Hillingdon

Outline Fire Strategy – Rev E

OF-OFS-3671-01-E

Appendix A – Drawing Comments

1 Building 3 - Ground Floor Plan
1 : 200

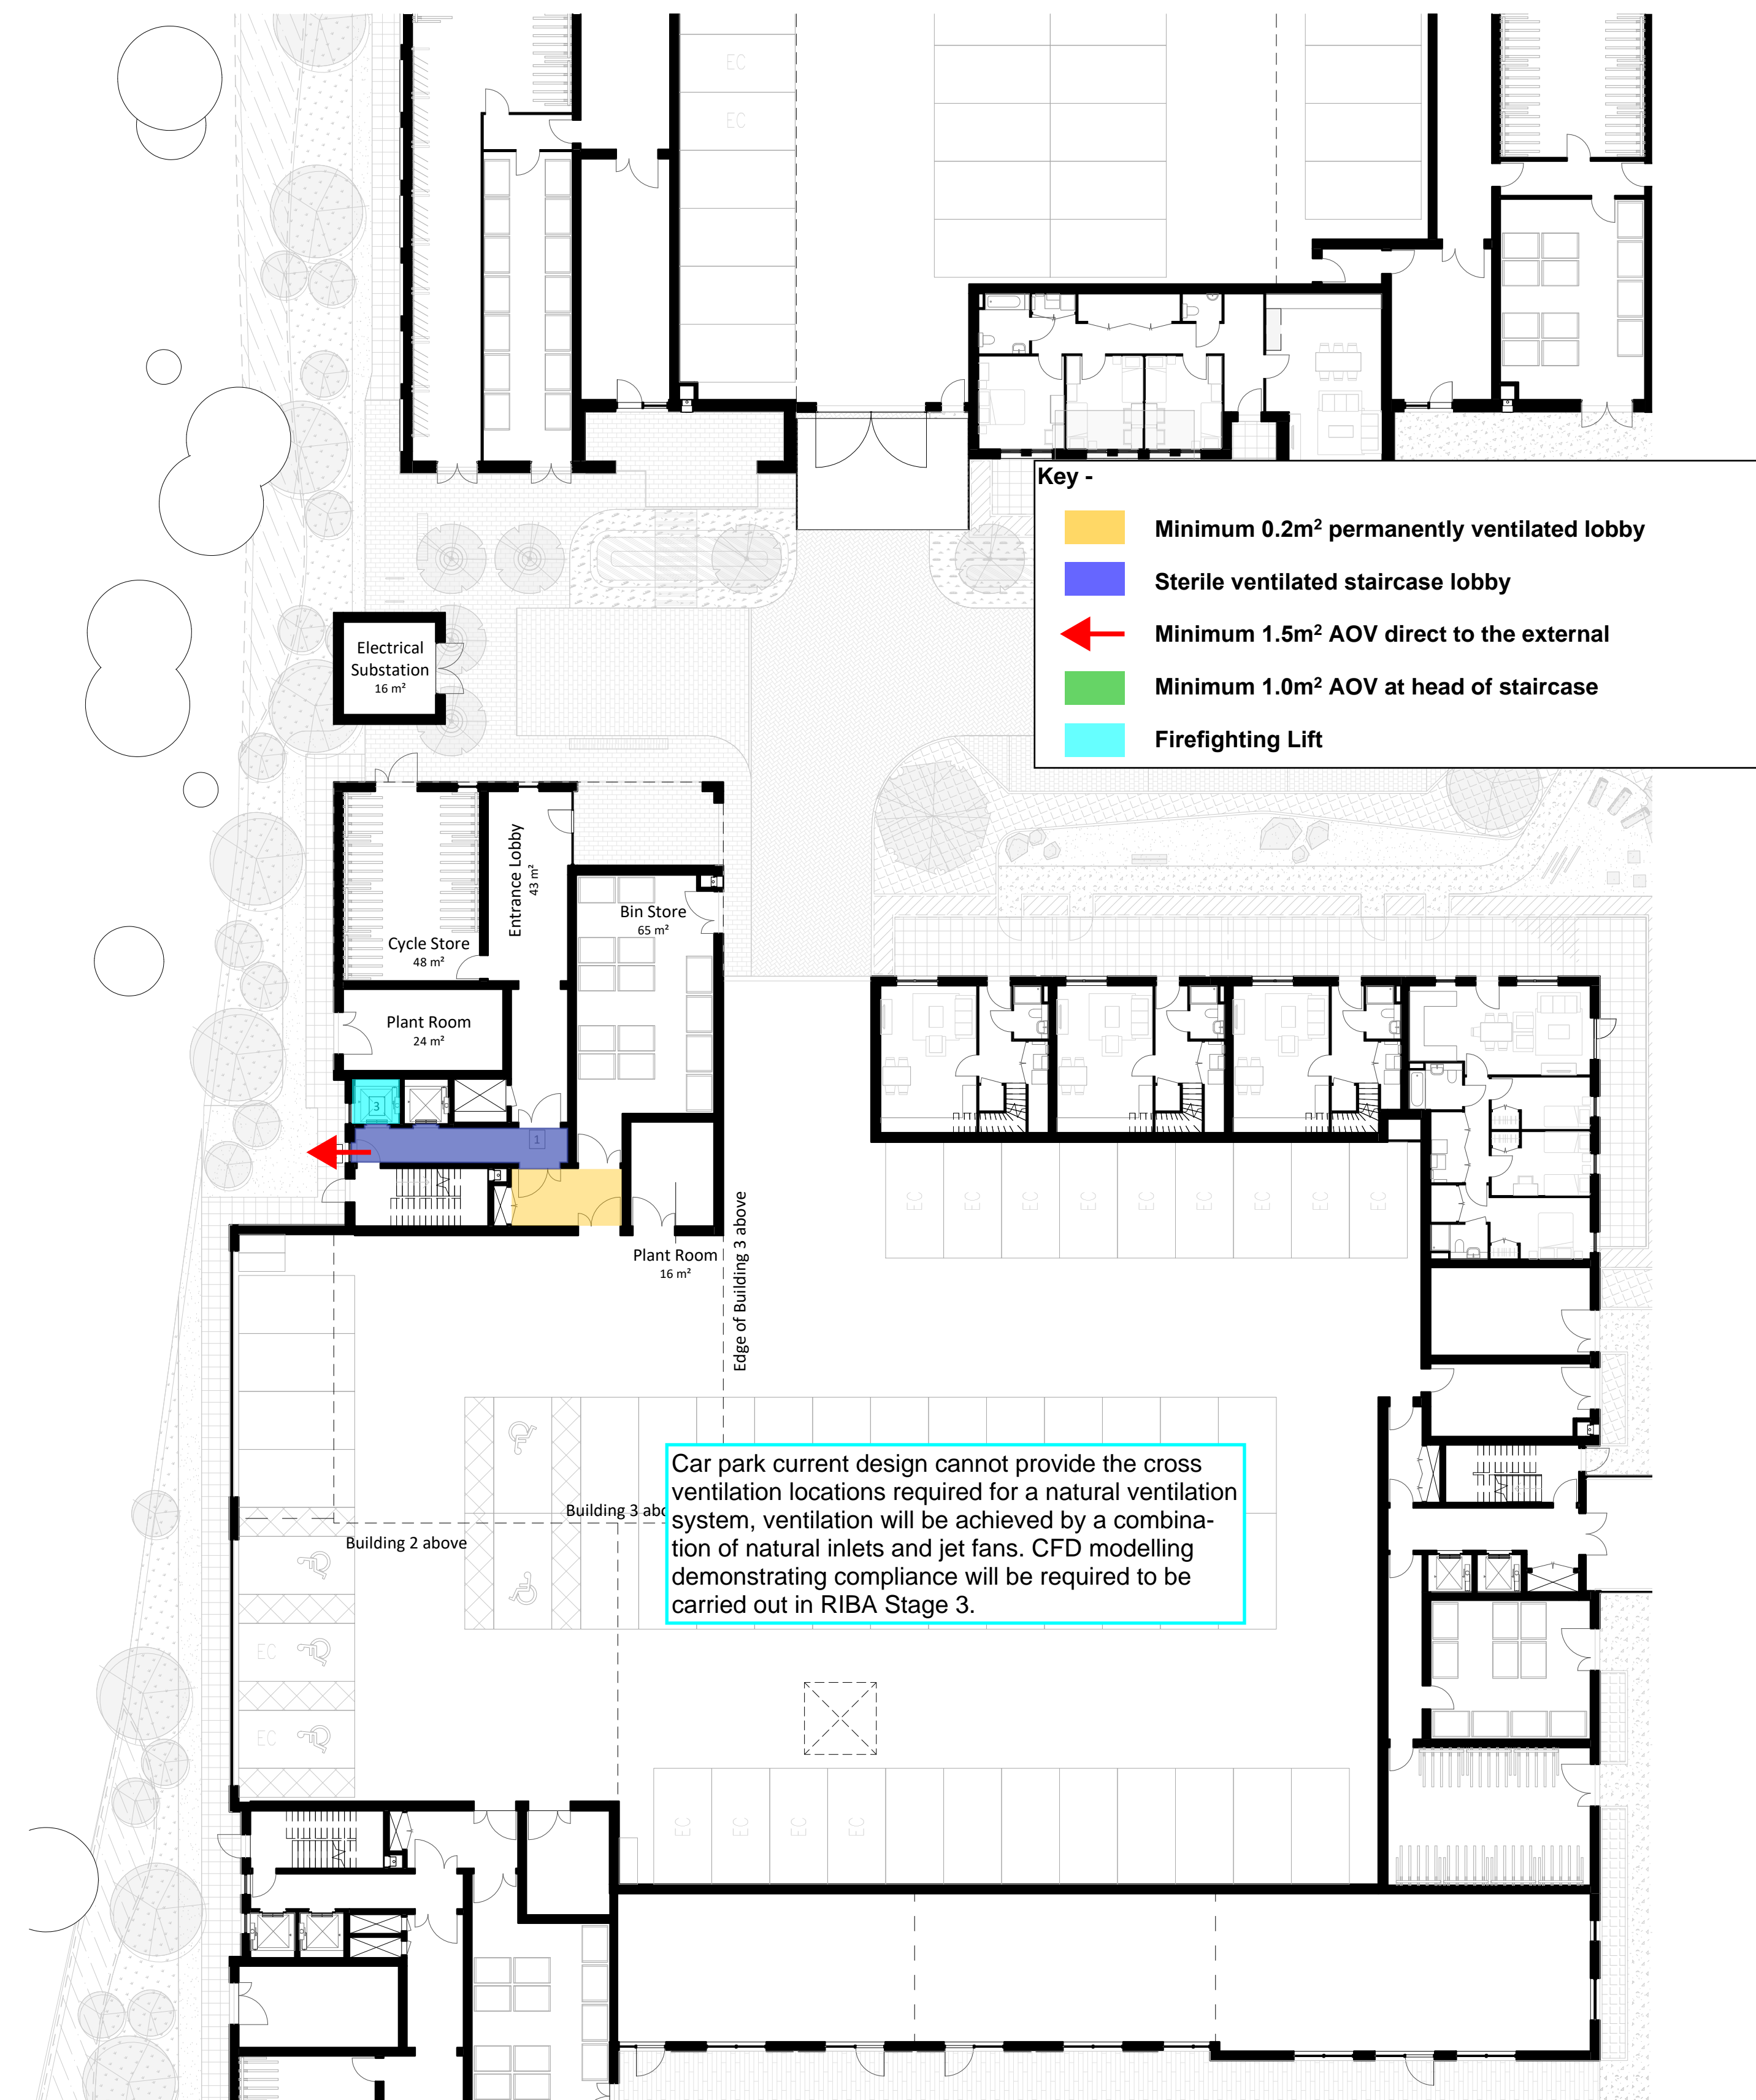
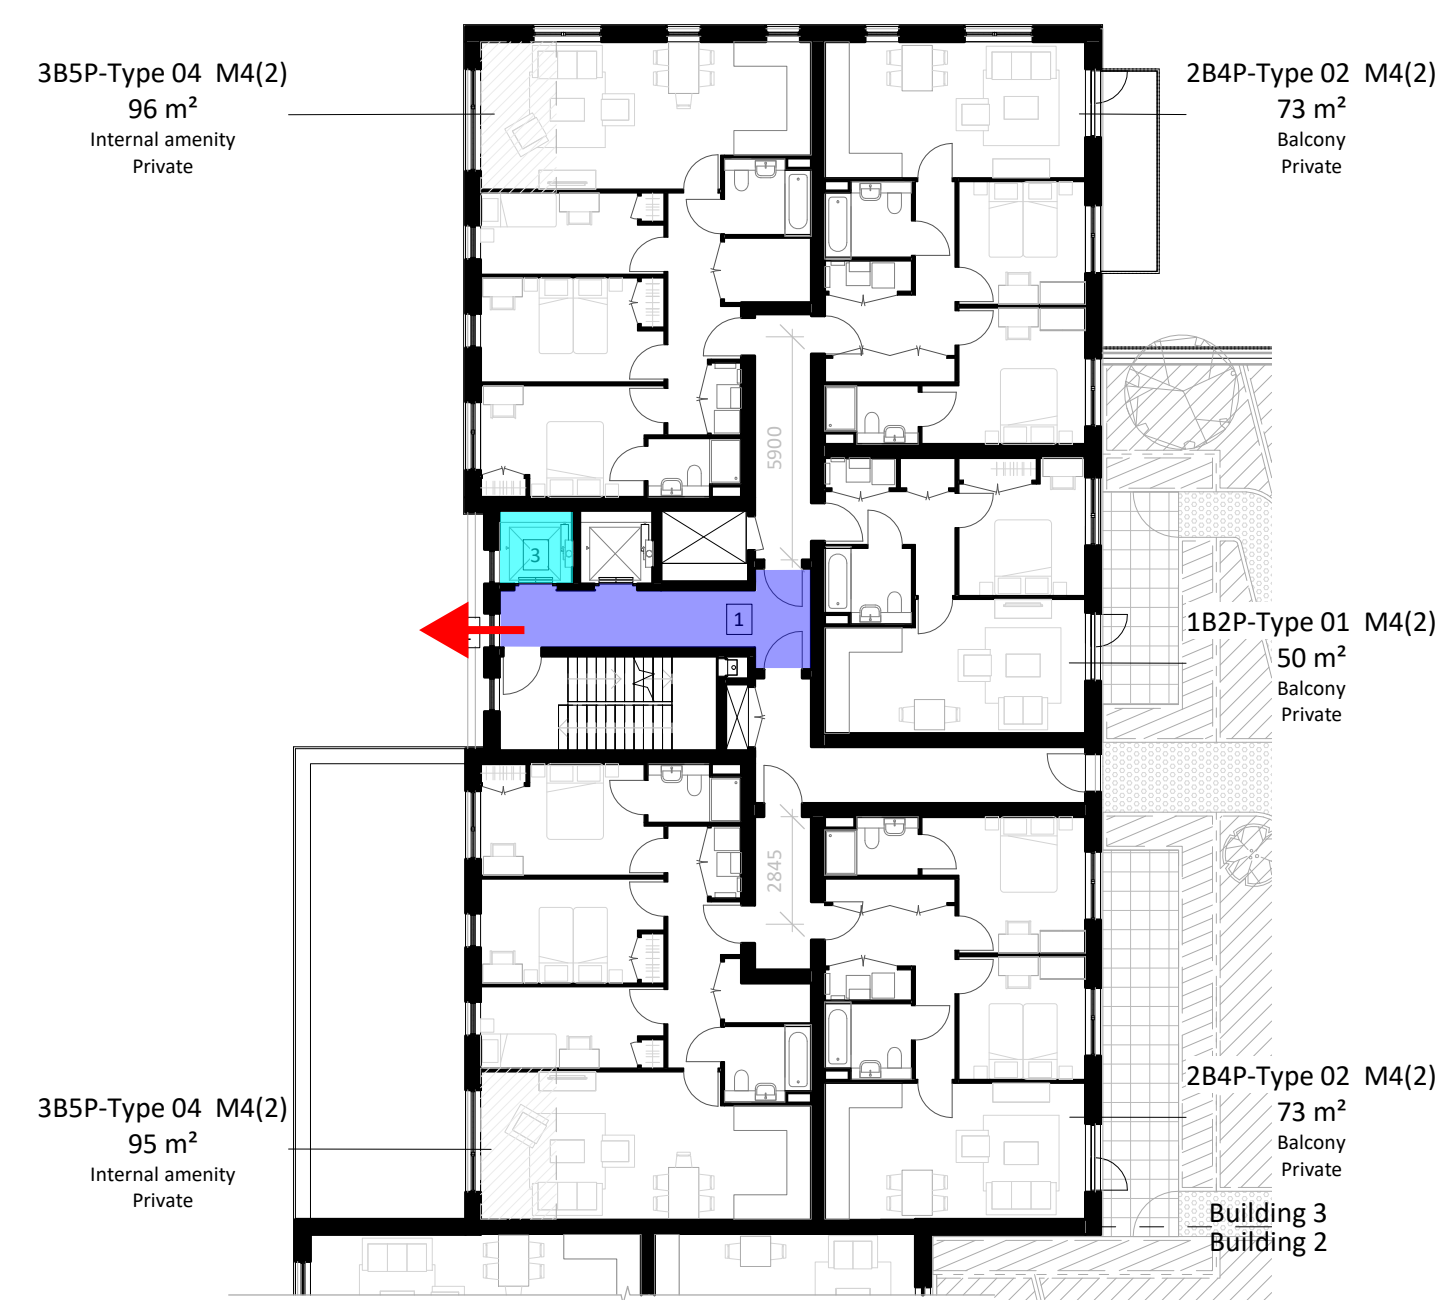
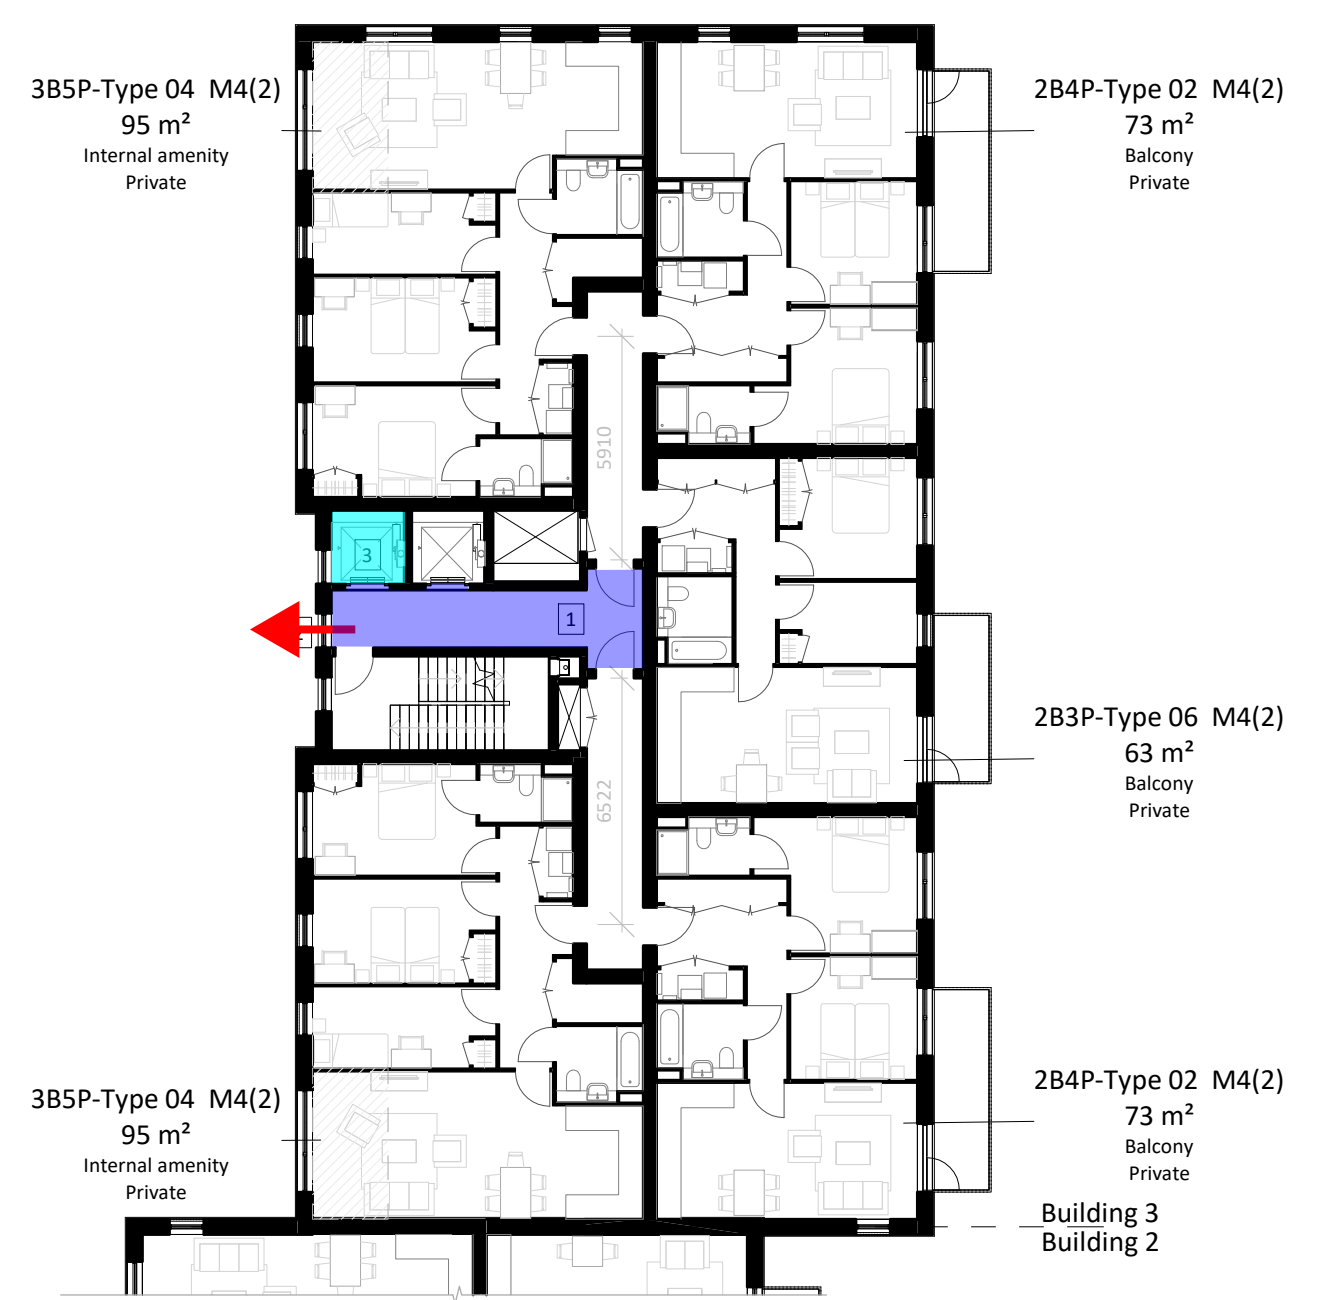
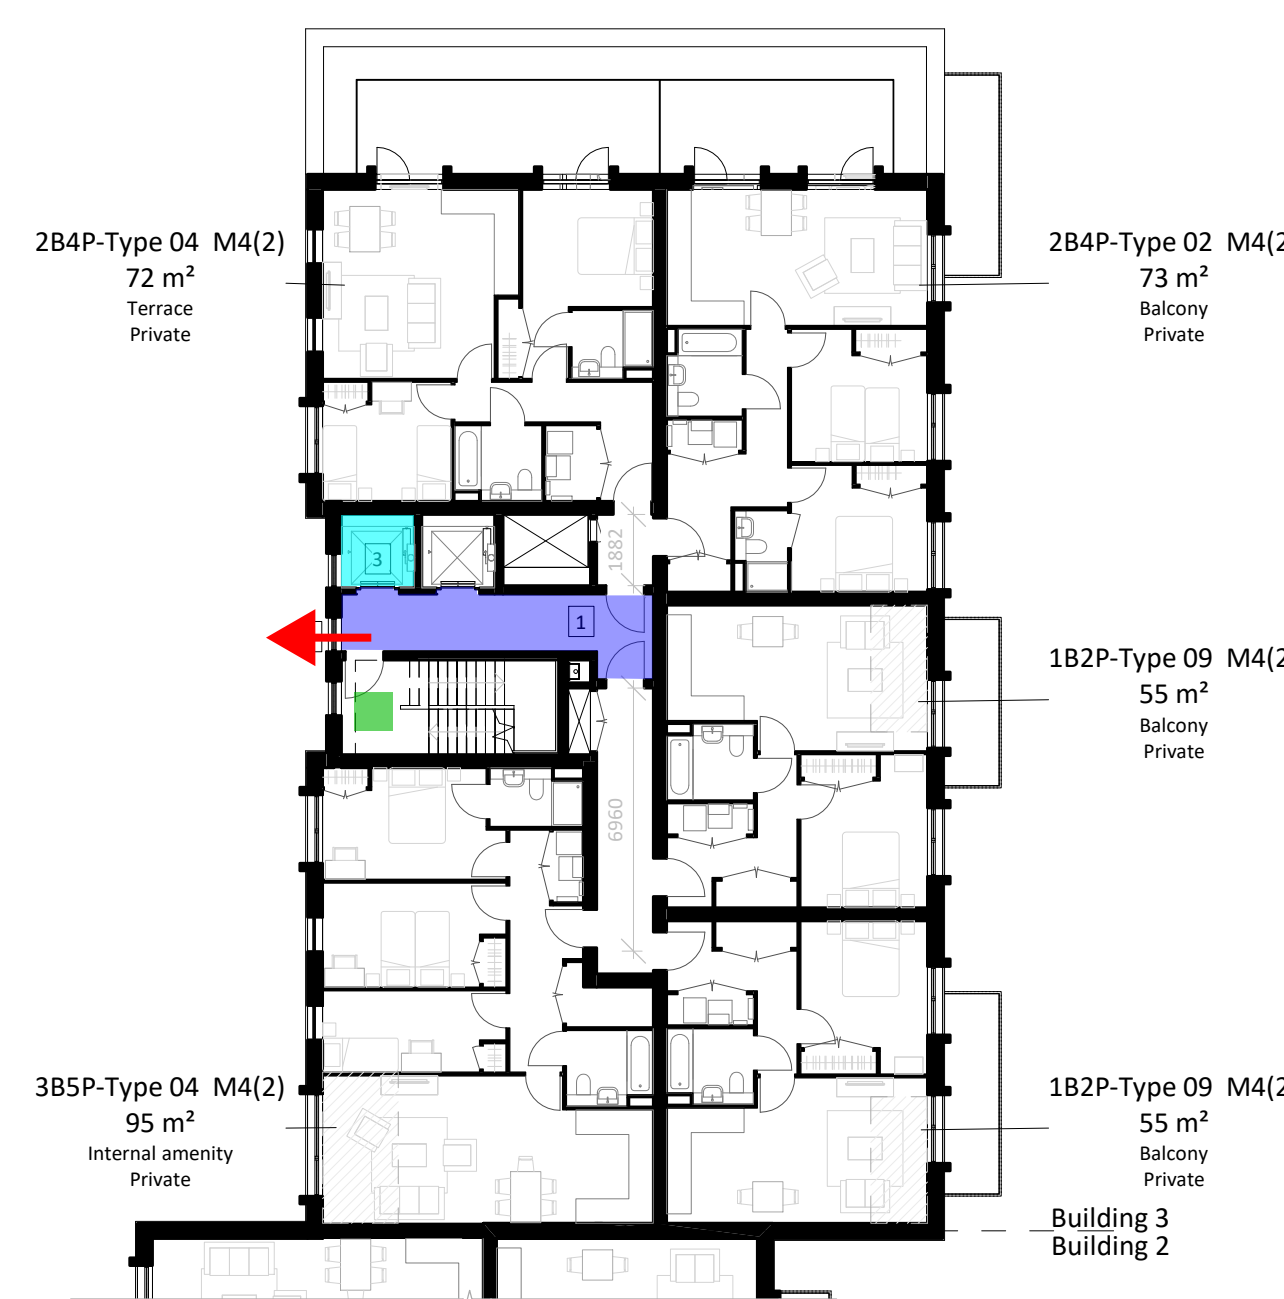
To be noted, if the service riser is to only contain water services or metal ventilation ductwork from the ground floor, it is considered a limited fire hazard. As such, this riser shaft may be located in the staircase lobby.

To be noted, the government have stated from May 2020, all new building's over 11m in height are required to be provided with sprinklers, see Section 9.
